# UNITED STATES PATENT AND TRADEMARK OFFICE

APPLICATION NO.	FILING DATE	FIRST NAMED INVENTOR	ATTORNEY DOCKET NO.	CONFIRMATION NO.
10/725,259	12/01/2003	Leo W. Spychalla	10413US01	2950
7590	12/15/2005		EXAMINER	
Eric D. Levinson Imation Corp. Legal Affairs P.O. Box 64898 St. Paul, MN 55164-0898			PAPE, ZACHARY	
			ART UNIT	PAPER NUMBER
			2835	
DATE MAILED: 12/15/2005

**Office Action Summary**

## **DETAILED ACTION**

Fig 1

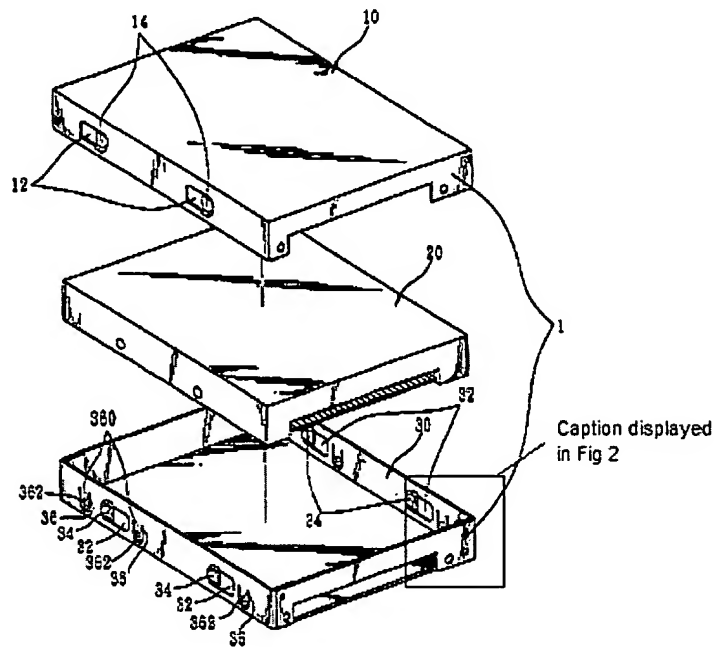
With respect to claim 1, Lu et al. teaches a housing (Fig 1, 10, 30) defining an interior cavity (Space in which hard disk drive 20 is placed), an access window (as shown in Fig 1) and at least one alignment feature positioned within the interior cavity (See present office action Figs 1 and 2 below) and a hard drive (Fig 1, within casing 20) maintained within the interior cavity, the hard drive having at least one electrical connection point (22). Lu et al. fails to teach that the housing includes a polymeric

With respect to claim 21, Lu et al. further teaches that the housing (1) includes a first planar member (Best defined by the end of the arrow for numeral 1) defining the access window, and the at least one alignment feature (As illustrated in present office action Figs 1 and 2 below) extends from the first planar member (In a direction toward the hard drive) to interact with the hard drive to position the at least one electrical connection point to be contacted through the access window (As illustrated in Lu Fig 3).

With respect to claim 22, Lu et al. further teaches that the housing (1) includes a cover (10) and a base (30) coupled to the cover to define the interior cavity therebetween, the base defining the access window (In that the window is partially formed of the base 30 as best defined by the end of the arrow of numeral 1) and the at least one alignment feature (As illustrated in present office action Figs 1 and 2 below).

Fig 2

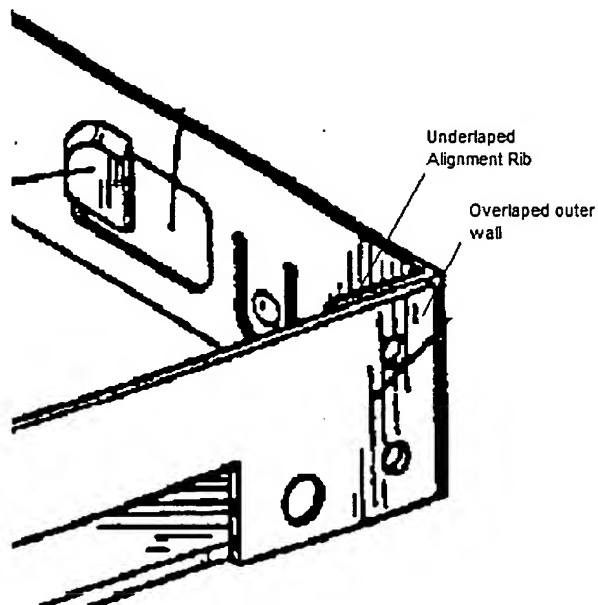
With respect to claim 8, Lu et al. further discloses that the at least one alignment feature of the housing includes an alignment rib defining a substantially planar surface extending in a direction substantially perpendicular to the access window (As illustrated

in the present office action Fig 2 below), the alignment rib being configured to align the at least one electrical connection point relative to the access window in the Y-direction.

With respect to claim 10, Lu et al. further teaches that the alignment rib is positioned adjacent the access window (See present office action Fig 2 below).
